## Planning and Zoning Board

**CASE NUMBER:** Z16-017 (PLN2015-00585)  
**LOCATION:** 5850 through 5959 East Still Circle  
**GENERAL VICINITY:** Located north of Baseline Road and west of S. Recker Road  
**REQUEST:** PAD Modification and Site Plan Review  
**PURPOSE:** This request will allow for the expansion of a university academic building and parking structure  
**COUNCIL DISTRICT:** District 2  
**OWNER/APPLICANT:** Kirksville College of Osteopathic Medicine (dba A.T. Still University)/Toby Rogers – Butler Design Group  
**STAFF PLANNER:** Andrew Spurgin, Principal Planner

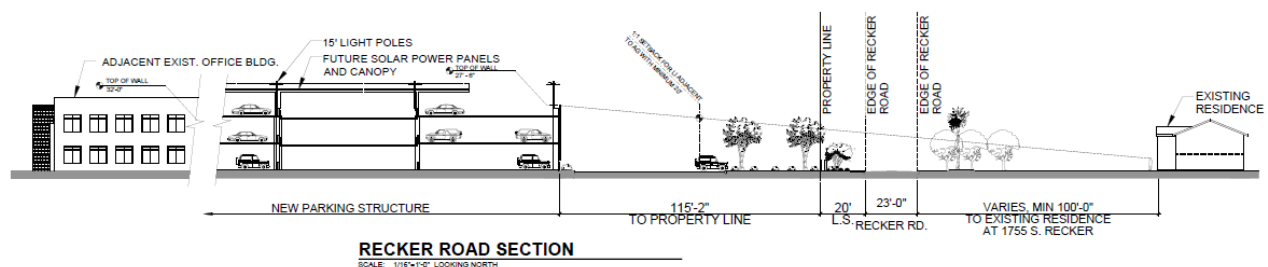
Compounding the University's overflow parking problem is an observed under-parked situation of the YMCA facility. The YMCA parking is barricaded to preclude connection with the existing University surface parking lots at the north end of the campus. When the YMCA facility was approved in 2007, a parking reduction was approved in the context of the larger PAD request to add the 4-story residential uses. The individual land uses associated with the YMCA such as the fitness area, pool, childcare, office and multi-purpose room would typically require 267 spaces following strict adherence to the Zoning Ordinance; the barricaded YMCA parking lot features only 83 spaces, less than one-third of the 267 spaces.
